OUR
TOWN
HALL
PROJECT

PROJECT STATUS	Riba Stage 5
CLIENT	Manchester City Council
PROJECT	Our Town Hall
DRAWING TITLE	Chimney CS24 East proposed repairs
SIZE & SCALE	A2: As indicated
DRAWING STATUS	S4 - Construction
JOB NUMBER	236959
DRAWING NO.	OTH-PUR-TH-RF-DWG-A-4204 02
REV

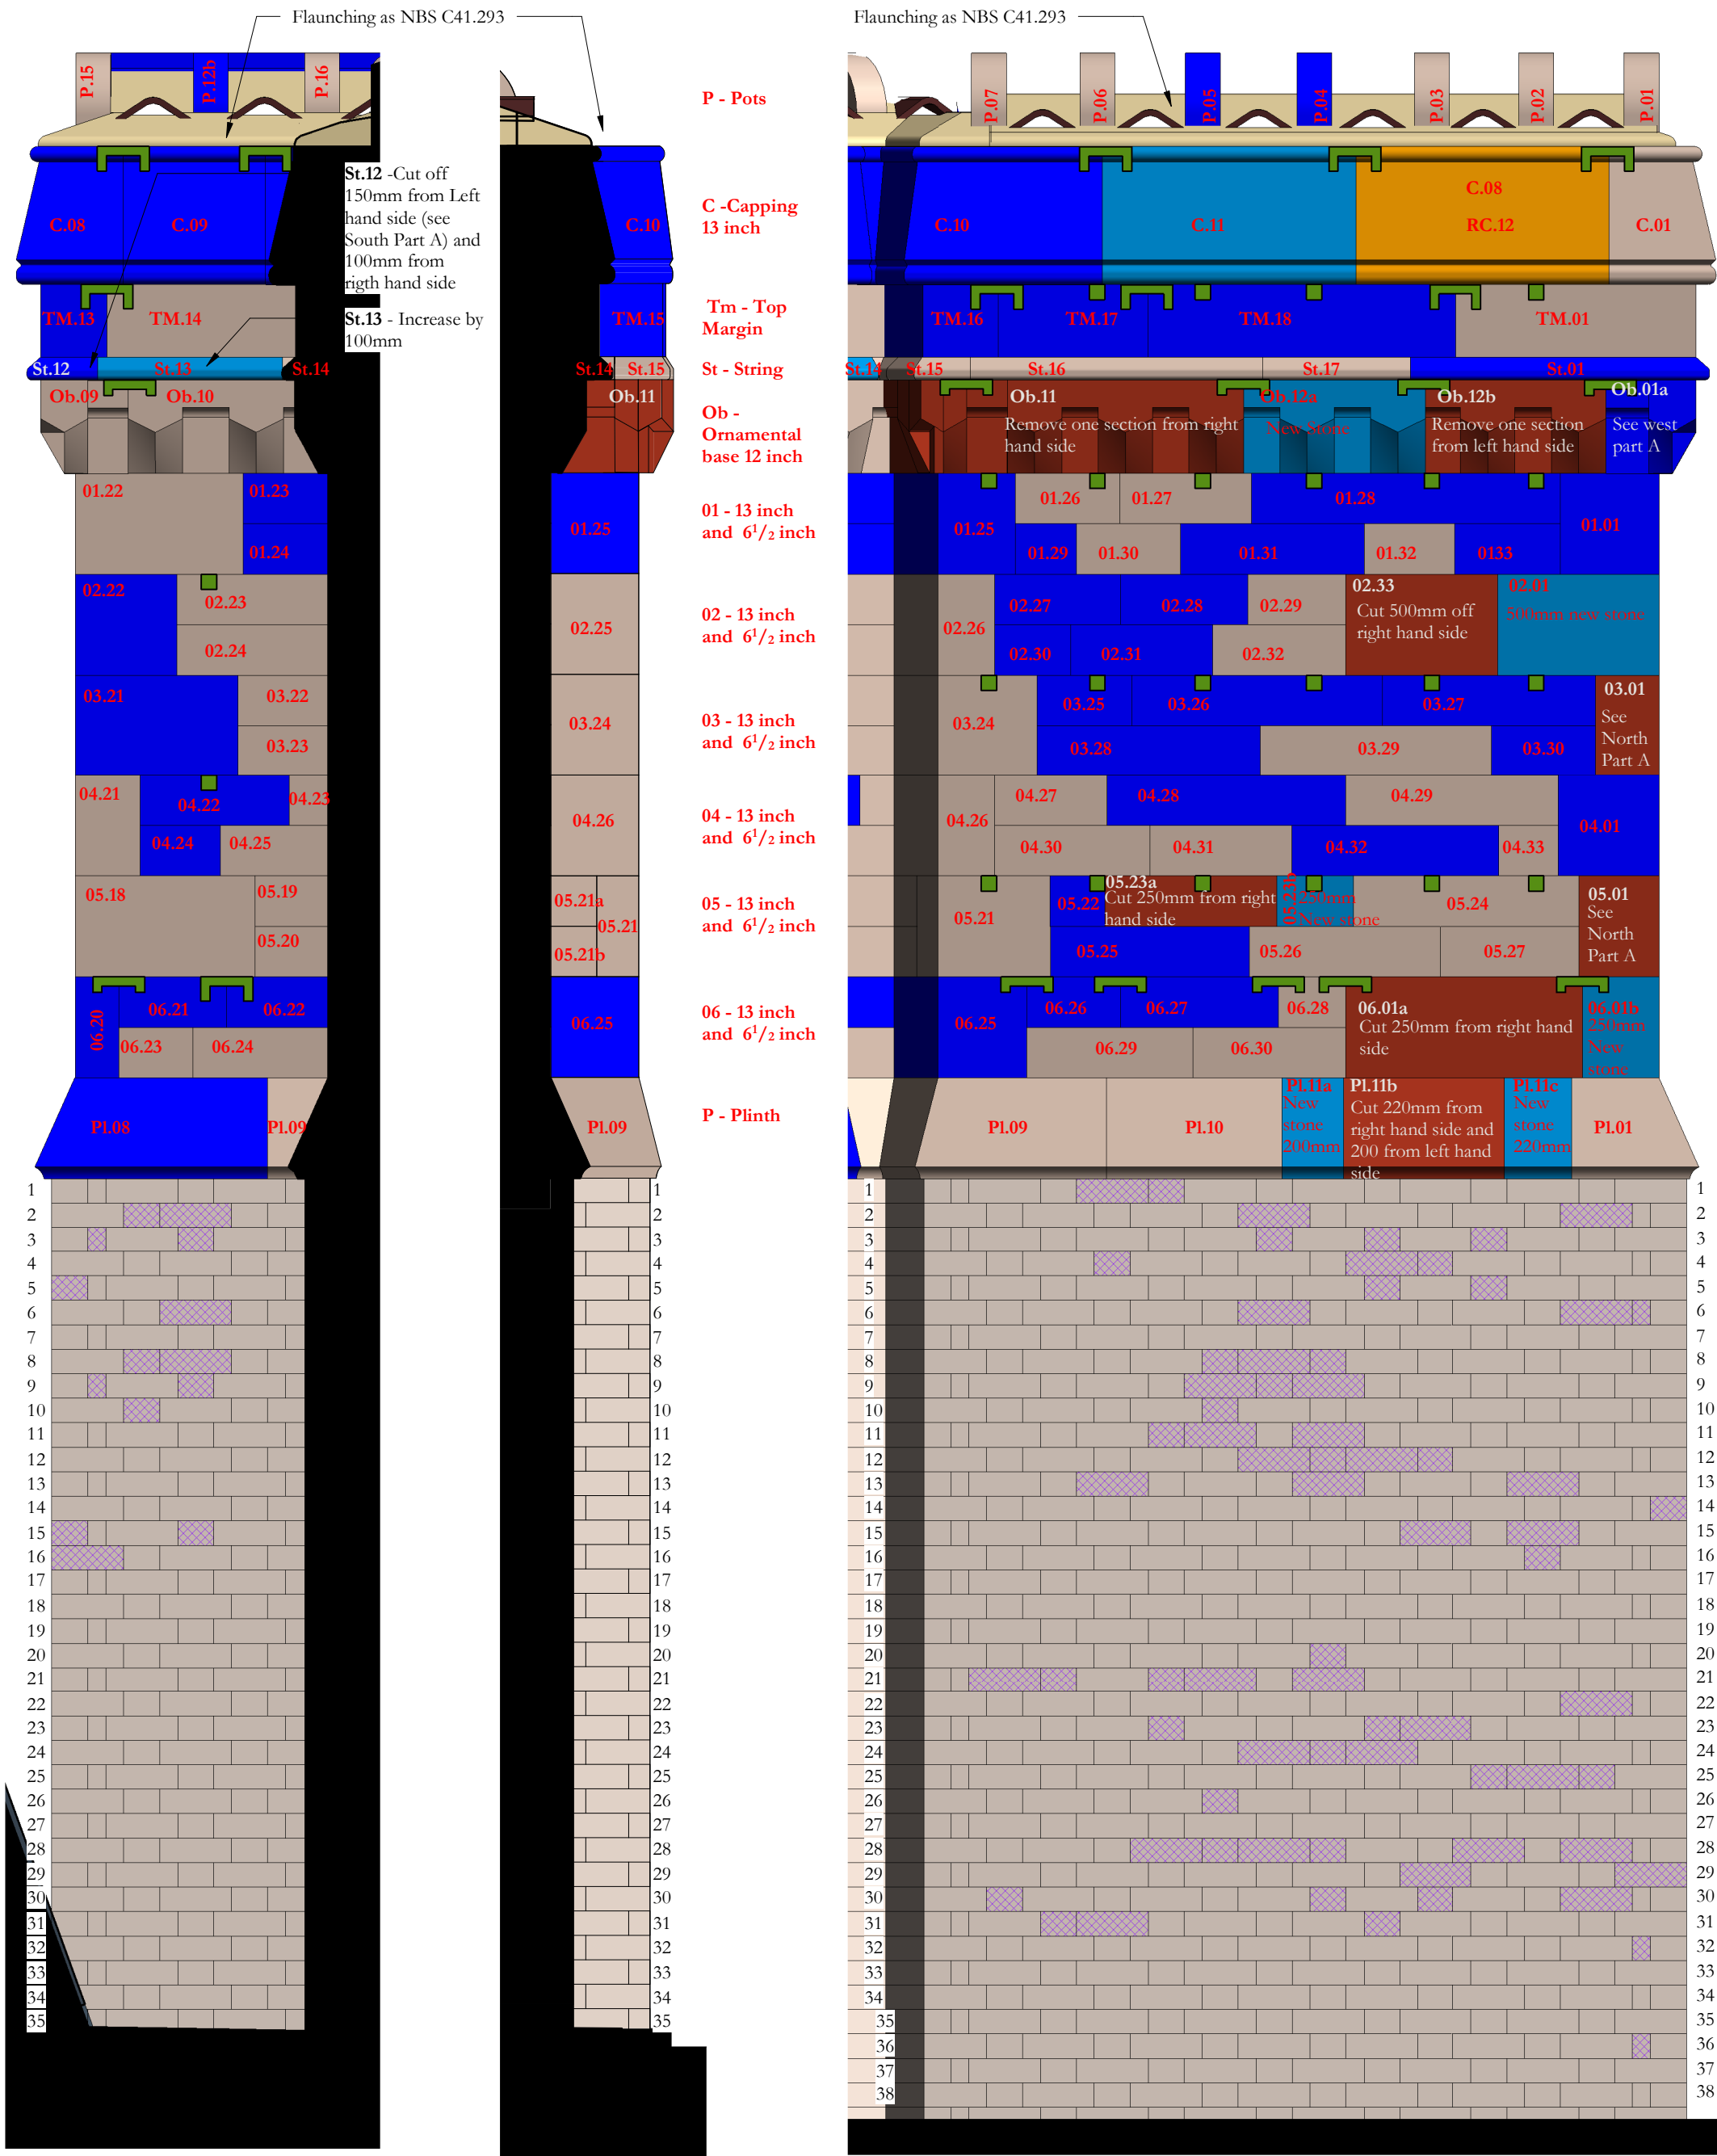
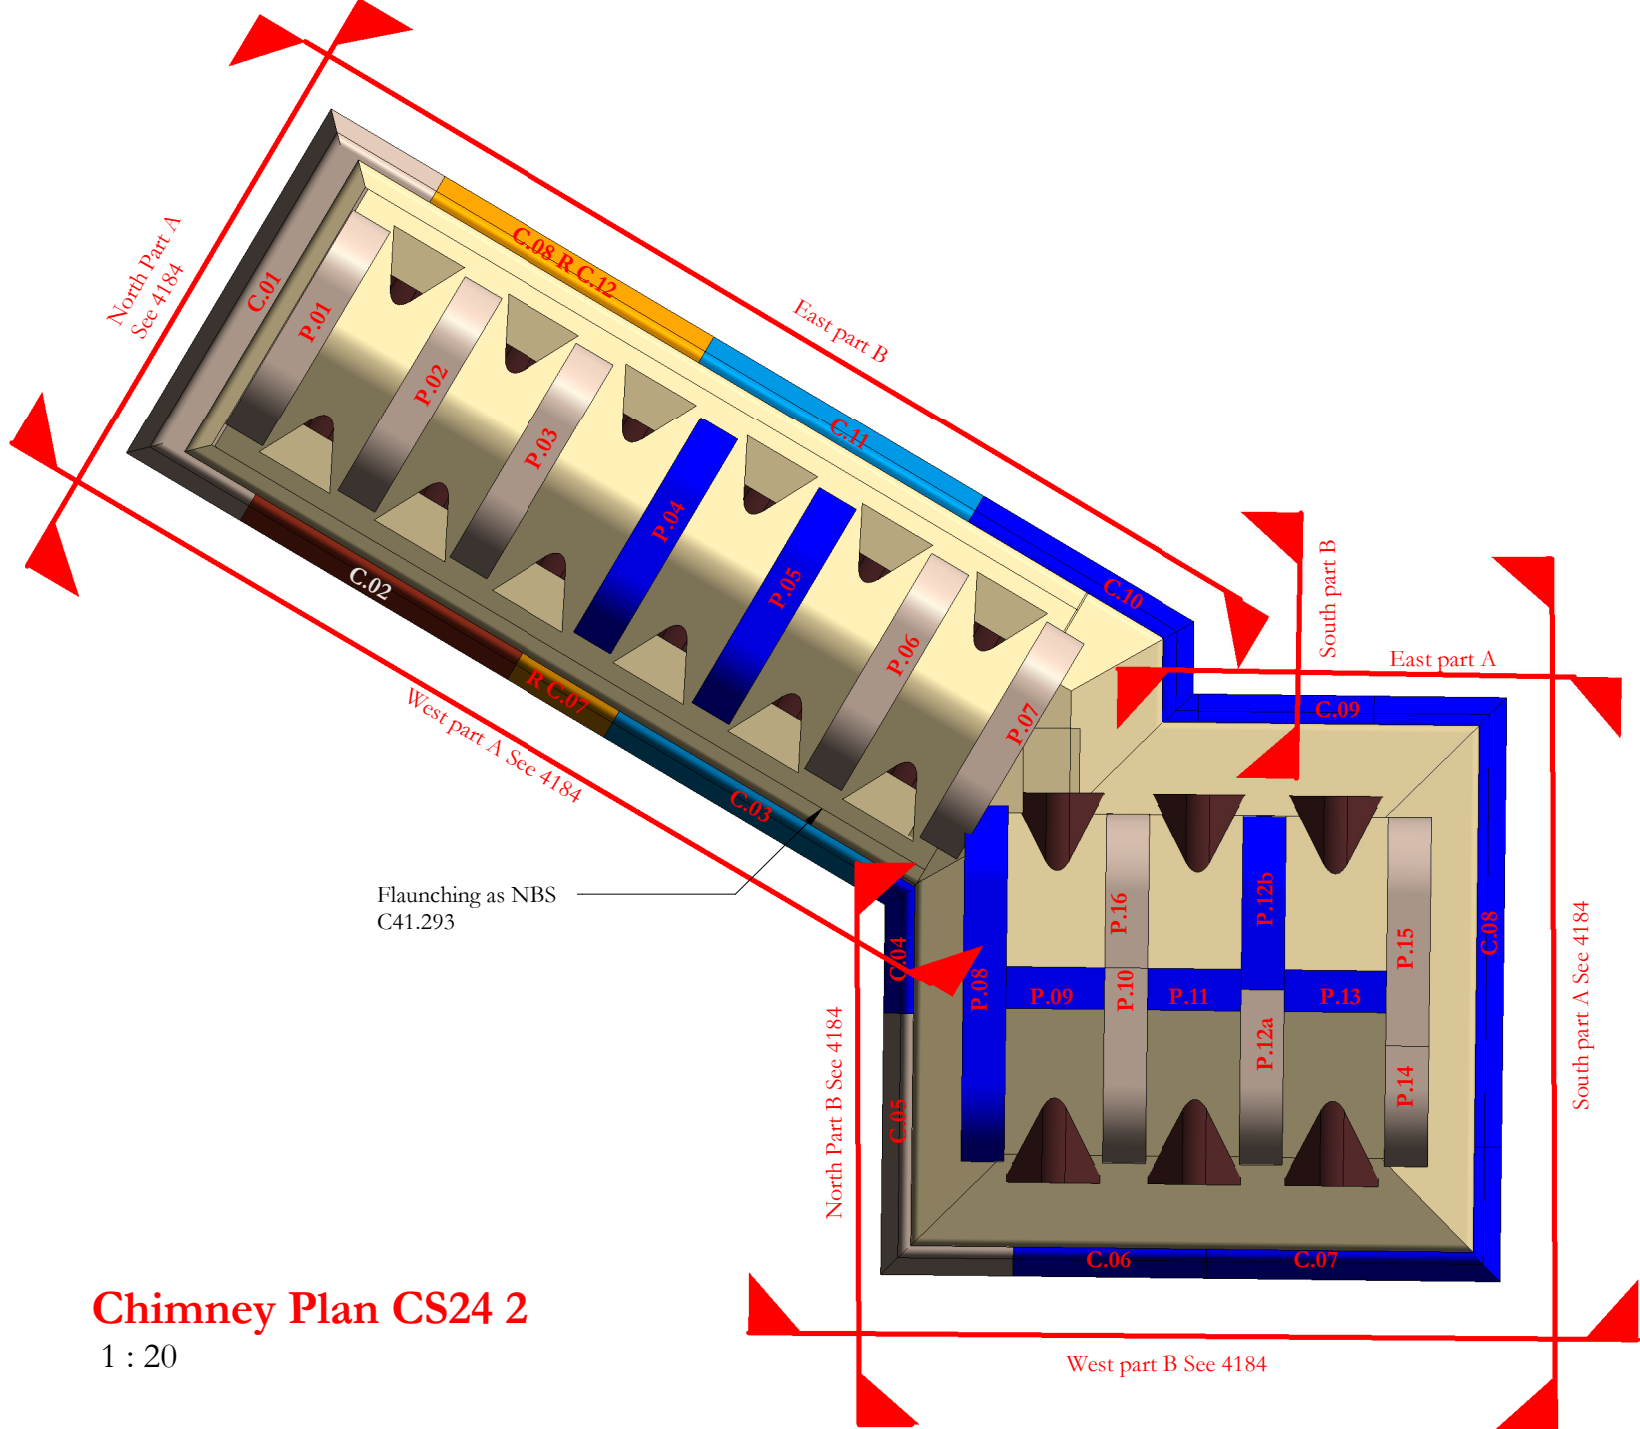
Revision 02
Cramps in Ob and course 6 amended to change all to 50mm leg. All cramps in string course moved to Ob course

Revision 01
Additional cramps and ties added to correspond with locations discovered on site. Additional replacement stones added: P11, P13, TM.01a, TM.08 Ob.01a, St.02, 01.01, 04.02, 05.08, 06.11, 06.12, 06.14, 06.15, 06.18, 06.20, 06.22, 06.25, 06.26, 06.27. Additional alterations to the following components: Existing stone 06.17 to be cut down and new stone 06.14 increased to compensate; Existing string St.04 cut down and new string St.03 increased to compensate
